**DRC**  
**SITE PLAN REVIEW AND COMMENT**  
**REPORT**

**Project Name:** Third Avenue Associates, Ltd./Las  
Olas Place

**Case #:** 30-R-02

**Date:** March 12, 2002

## Exhibit 1 – Projected Impact Area

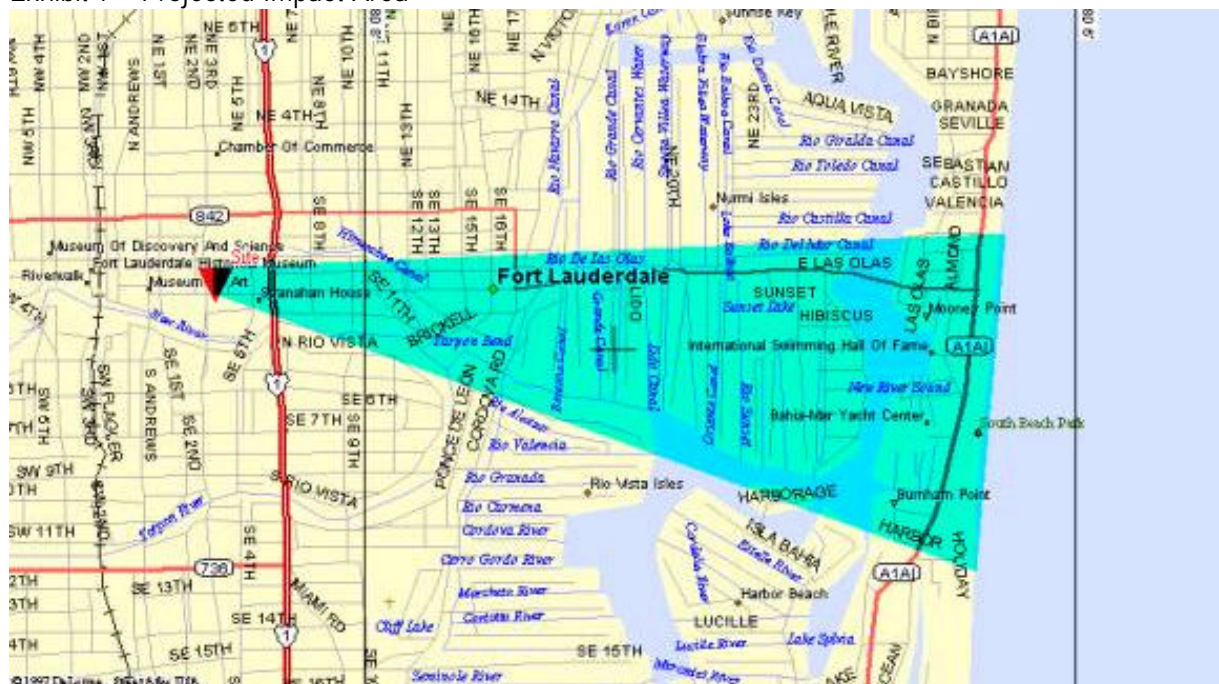
This site plan will adversely impact Public Safety radio communications in the future. This project is anticipated to severely impact radio communications within the buildings located directly to the east of this project site in the area depicted on the attached map. The combined effects of building construction in Fort Lauderdale is having an adverse impact on the performance of the Public Safety Radio Systems used by Fire Rescue and Police. Costs of mitigating the impact on the City's Radio Systems shall be born by the developer. Due to the severity of the impact, mitigation costs may be substantial. In the future, the developer may be required to provide mitigation resources at sites other than this project location.

An internal bi-directional amplifier system will be required to address communications issues within this building.

The City will require an easement to utilize the roof for communications infrastructure components. This includes, but is not limited to; antennas, base stations, UPS power supplies, and microwave dish antennas. The building owners shall provide a secure climate controlled room, no less than 625 square feet, preferably 25x25x10, and suitable for sensitive electronic equipment. This room shall be located within the top floor or roof area to allow for less than one-hundred (100) foot cable runs to the antenna locations. Power for the equipment in this room shall be fed from the building emergency generator. The developer shall provide one or more antenna mounting structures that are capable of supporting no less than 10 individual whip style antennas spaced no less than 4 feet apart and two 10-foot diameter microwave dishes. Additional construction specifications will be made available as required.

To address the internal building Public Safety Radio System coverage the City requires that a bi-directional amplifier system be installed to distribute the radio signals to each floor. These bi-directional amplifier systems can be designed and installed by any experienced radio communications firm using City provided performance specifications.
